OMNIPOL PRAHA ČESKOSLOVENSKO

Mandatory Bulletin No. L 13/047

Subject: A. The L-13 sailplanes Serial Nos 170101 up to 174730.
B. The L-13 sailplanes Serial Nos 170101 up to 170320.

Reason: A. To increase rigidity of No. 1 bulkhead at the location of tow-rope hinge control-system countershaft bracket.
B. To secure tow-rope hinge control-system countershaft (by means of bolts, nuts and washers) against accidental sliding out of bracket bearings.

Stiffeners (pos.1,2) can also be made acc. to Fig. 3. (left-hand stiffener L 13. 807-12.21 shown only, the right - hand one being its mirror image).

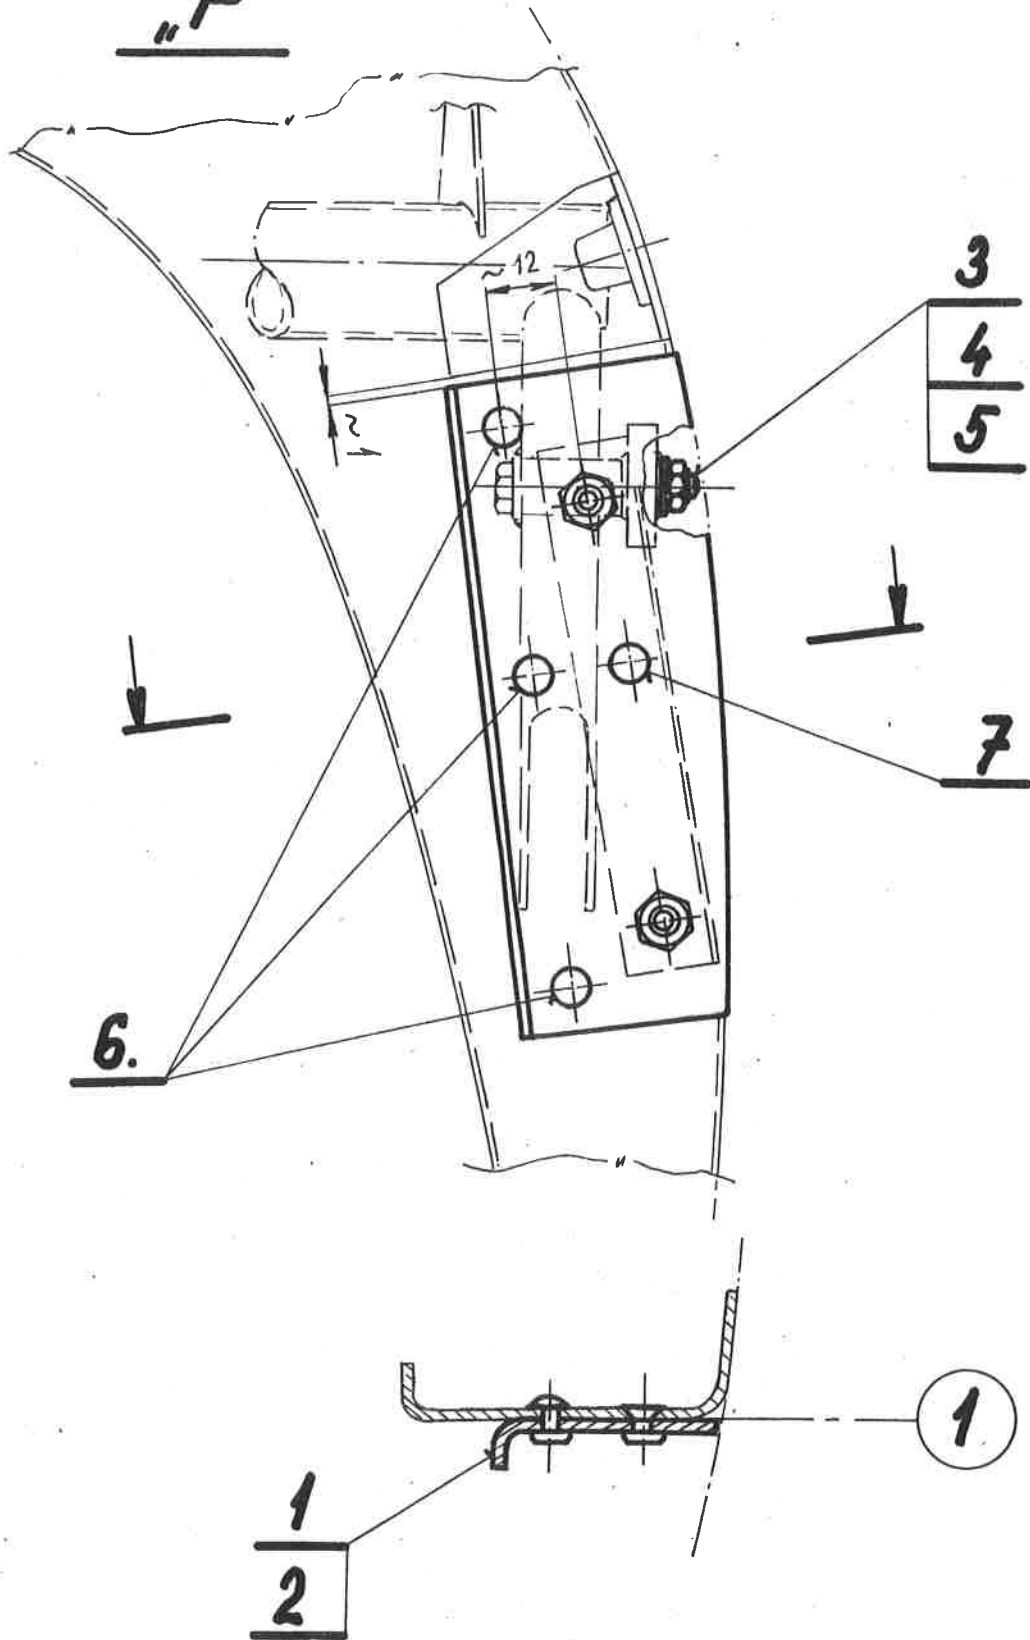
Material: 424253.61 - duralumin, tensile strength after hardening 392 MPa (40 kp/mm²).

Dimensions: sheet 1.6 mm thick, size 32x90.
